## **MIDWEST POOLED FUND PROGRAM**

### **Progress Report - Third Quarter 2010 July 1<sup>st</sup> to September 30<sup>th</sup>**

Midwest Roadside Safety Facility  
Nebraska Transportation Center  
University of Nebraska-Lincoln

## **Pooled Fund Consulting Summary**

Figure 14. PCB Transition Questions

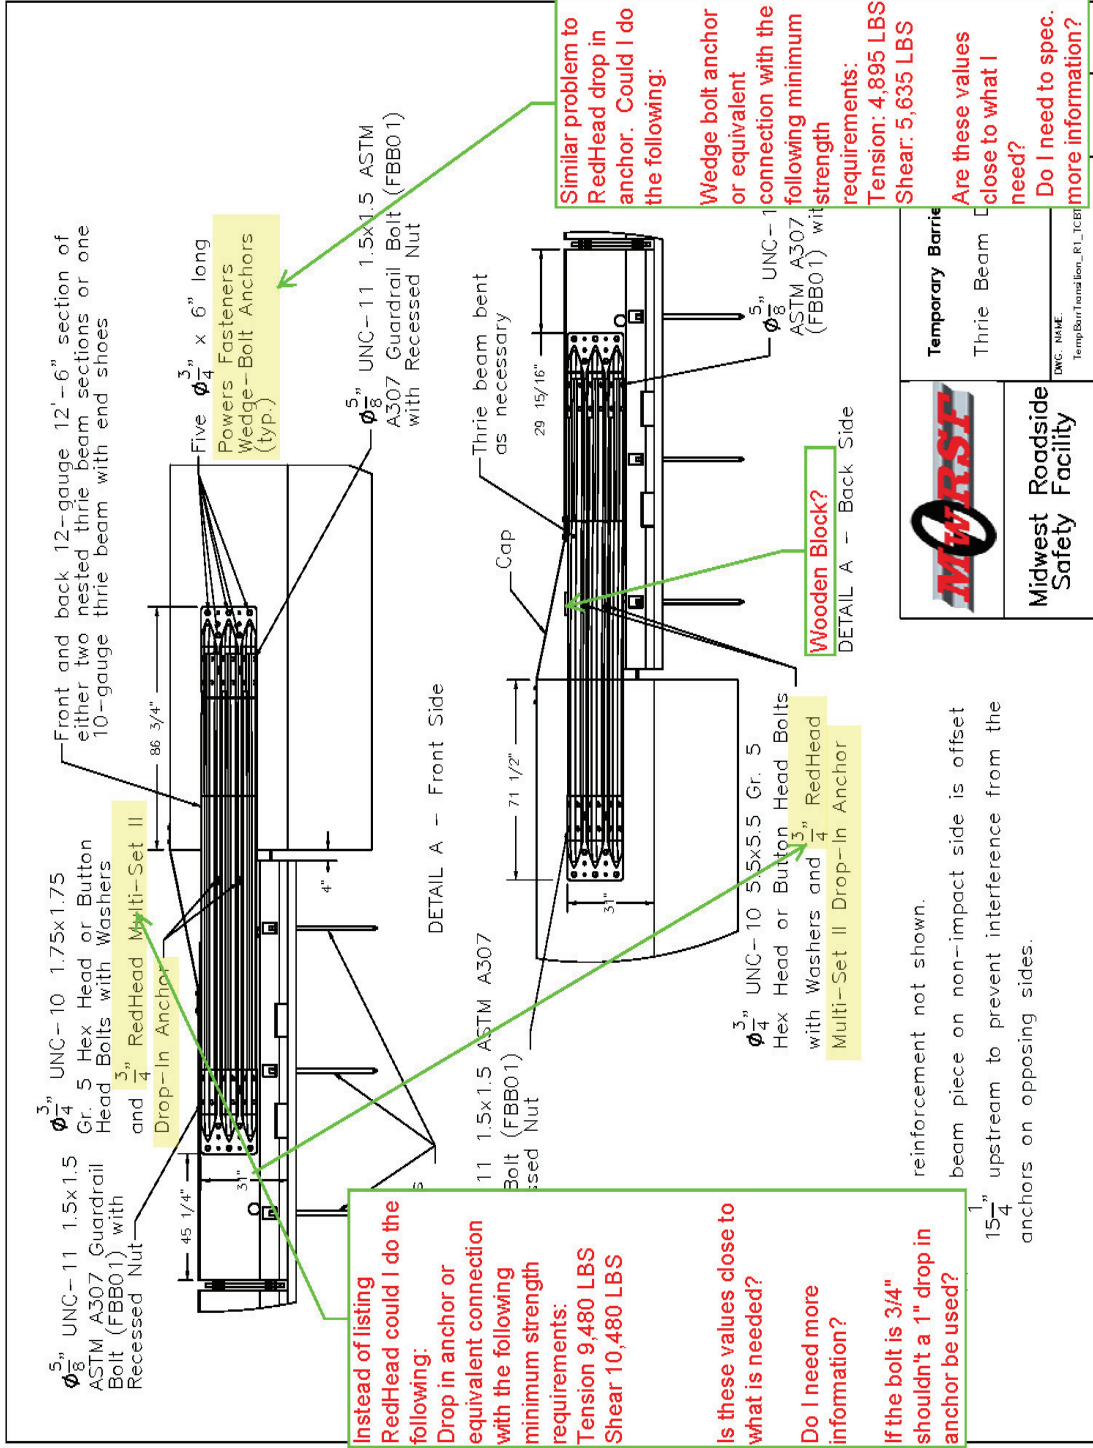
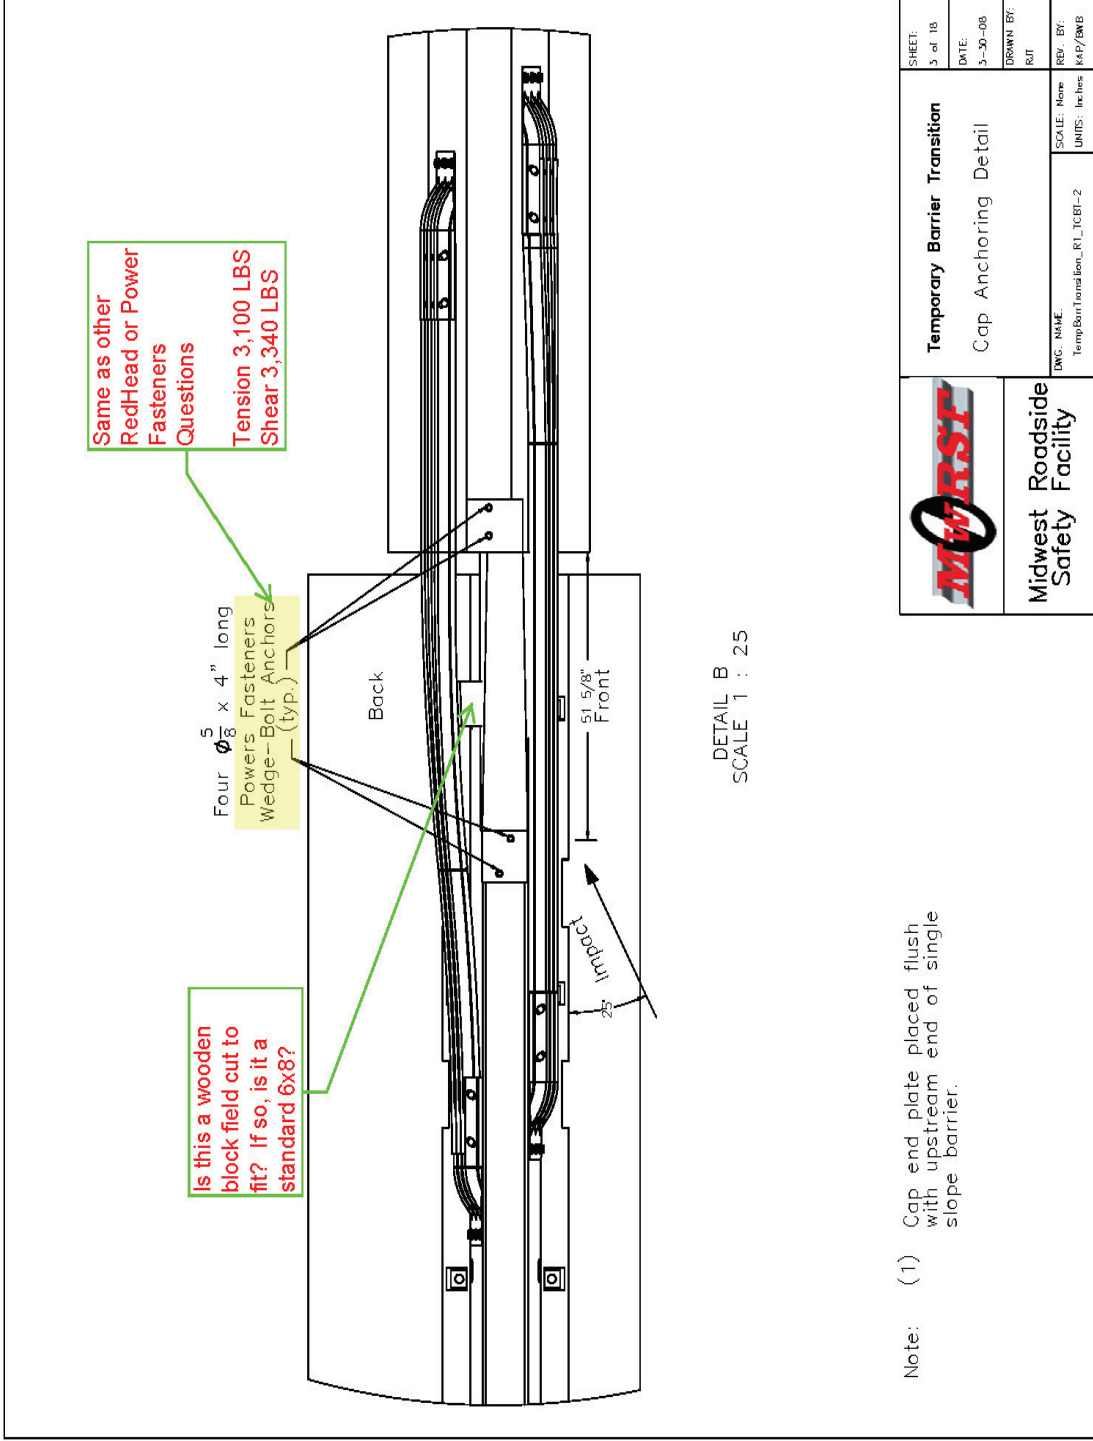
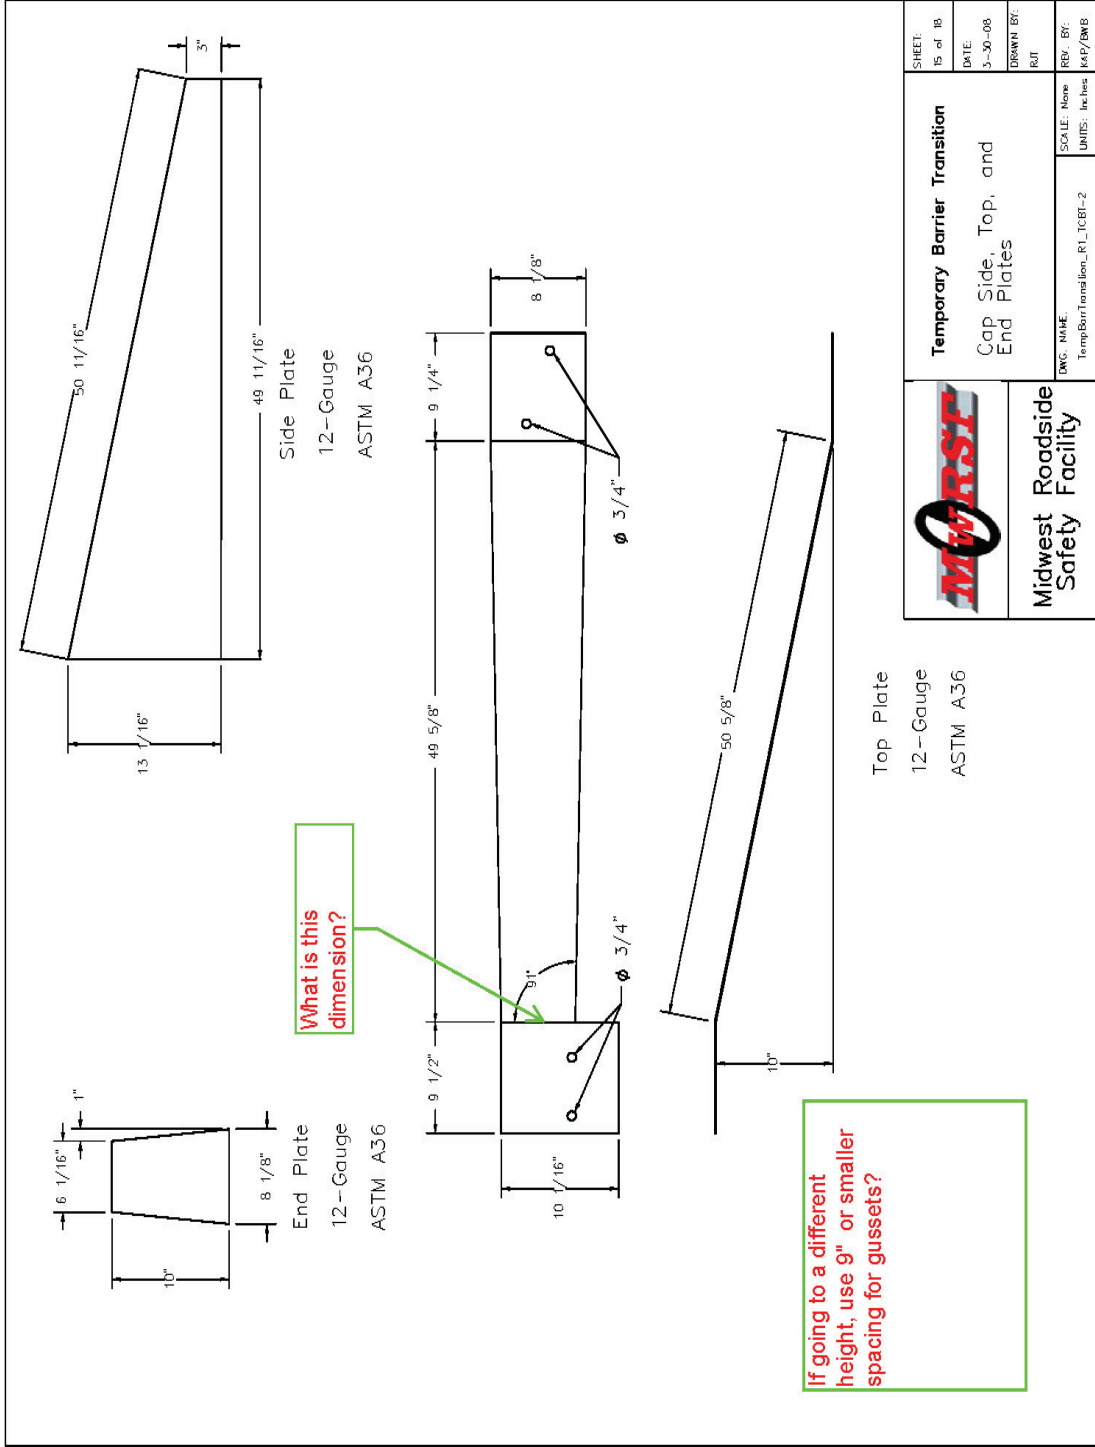
I'm working on incorporating the transition from temporary barrier to permanent barriers. I've run across some questions (see attached) that I would like MwRSF to address.

I have reviewed your questions and have some answers below.

Figure 17. Oregon PCB

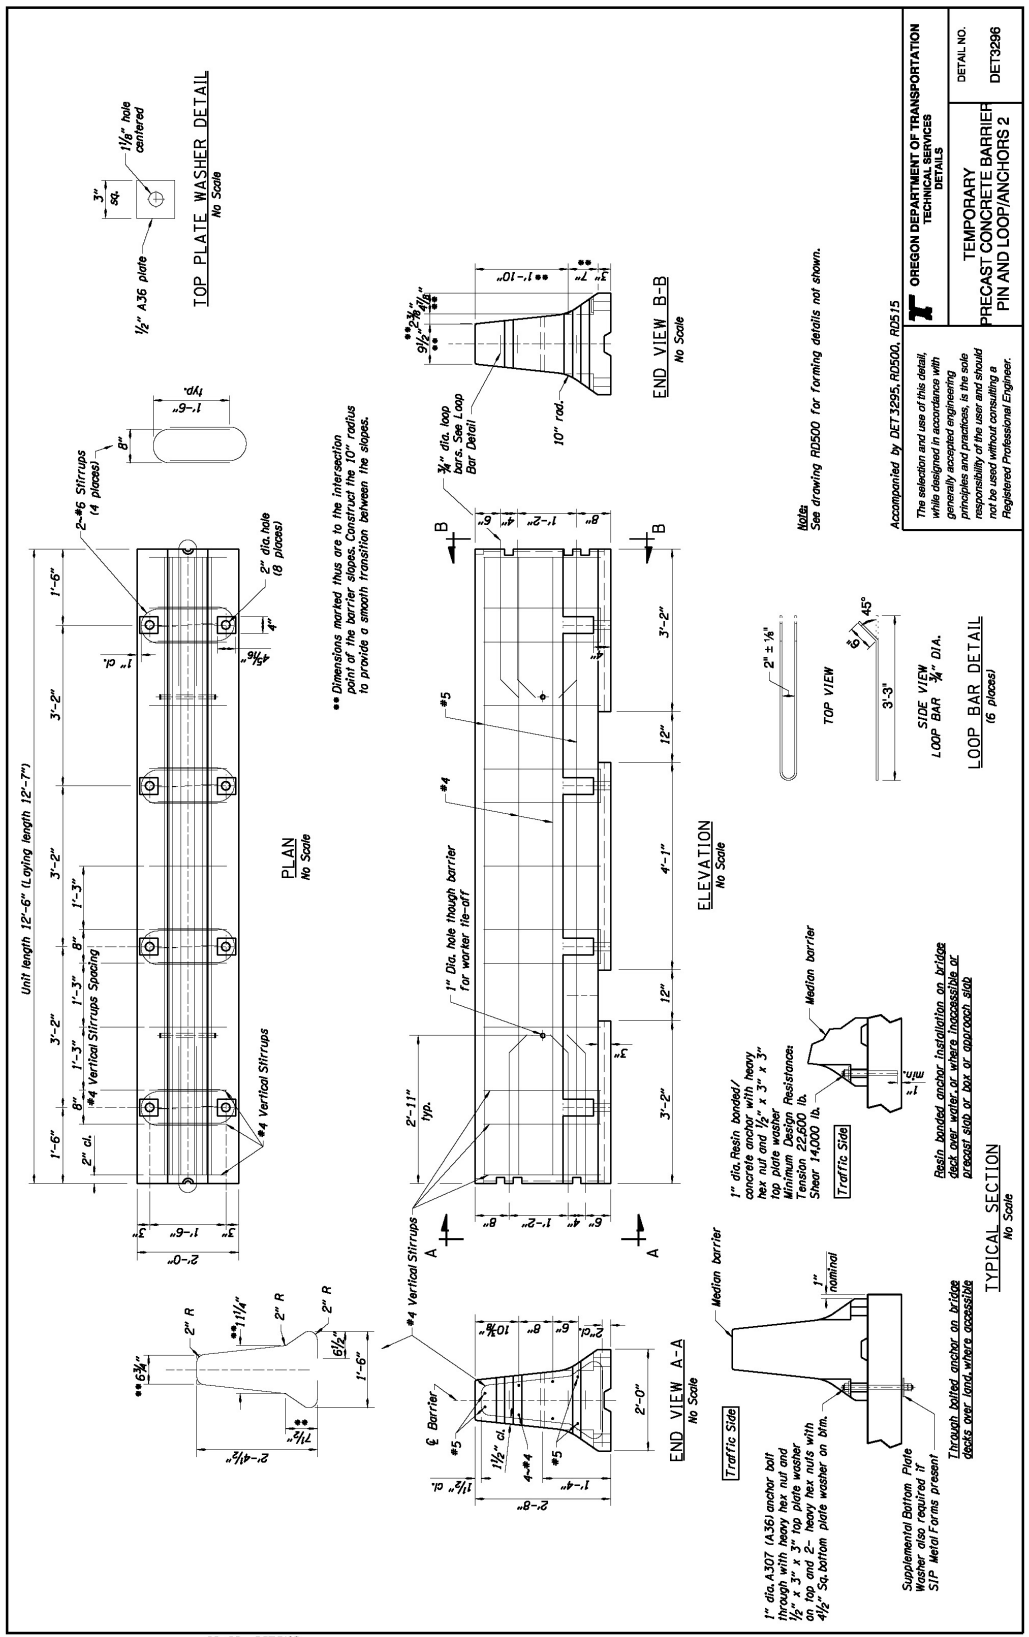
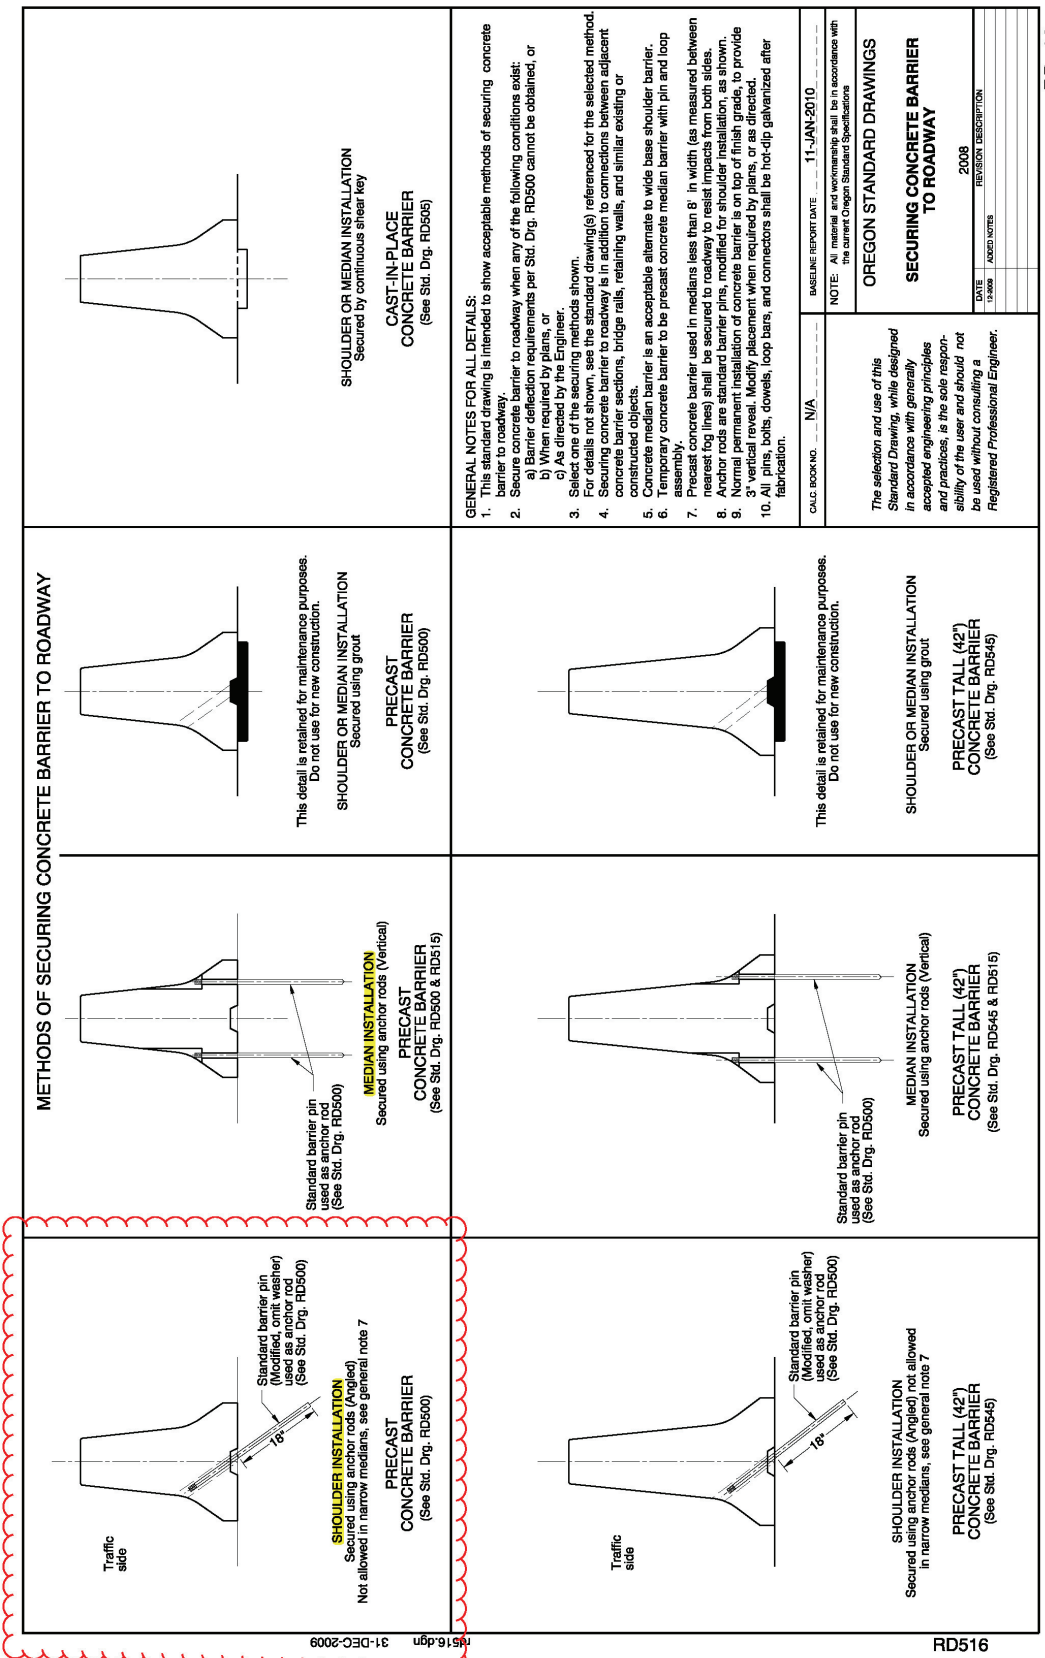
Or should the Median Installation (2 pins) be used, even though there are "two layers of defense"? (Note 7 indicates that 2-pins are needed for a median of less than 8', but does this include 2 barriers?)

Does this detail in conjunction with a sliding distance of 500mm away from the impact side provide a crash tested barrier that should be considered safe for use in protecting median construction work and workers?

Is it necessary to have a design engineer seal the proposed design for a temporary use?

In general, anchorage options can be adapted over to alternative TCBs without actual crash testing if several conditions are believed to be met, including demonstration that equivalent or greater structural capacity is provided. Thus, one would require that the Oregon barrier provides equal or greater flexural capacity, shear strength, torsion resistance, etc. as compared to the as-tested TCBs where anchorage systems were evaluated. The Oregon joint detail should provide equal or greater strength between adjacent segments as compared to the as-tested TCBs. Barrier regions surrounding the openings where the vertical or sloped anchors are inserted in the Oregon barrier should provide equal or greater capacity as compared to the as-tested TCBs. The anchorage hardware should also provide equivalent structural capacity. Barrier lengths should also be similar. If these general conditions are met, then it would seem reasonable to adapt prior crashworthy anchorage options to similar TCBs.

MwRSF could provide you with research/test reports for anchorage systems that have been developed and crash tested at 100 km/hr for use with the Midwest F-shape TCB. TTI researchers would have similar information for those systems that were developed and tested by their personnel. Please let me know if you need further details and information. Thanks!

**\*\*I am not sure that I understand the question.**

**\*\*This is a question better suited for the DOTs. However, someone needs to ensure that the barrier hardware and its placement meet current safety practices.**
